# Product/Process Change Notice (PCN)

PCN #: PCN\_ WE-PD2HV\_20160322

Product Affected: WE-PD2HV series

Label example for pad printing  
(13<sup>th</sup> digit marked in red)

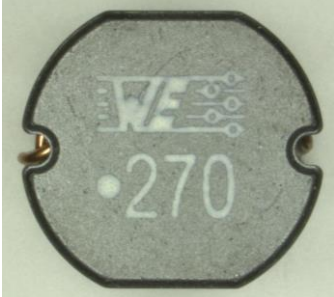
- 1.) Pad Printing and Laser-Printing will be used from now on.
- 2.) Printing method can be identified on the label by the 13<sup>th</sup> digit in the lot number.

Lot.-No. for Pad-Printing: xxxxxxxxxxxxx0xx

Lot.-No. for Laser-Printing: xxxxxxxxxxxxx2xx
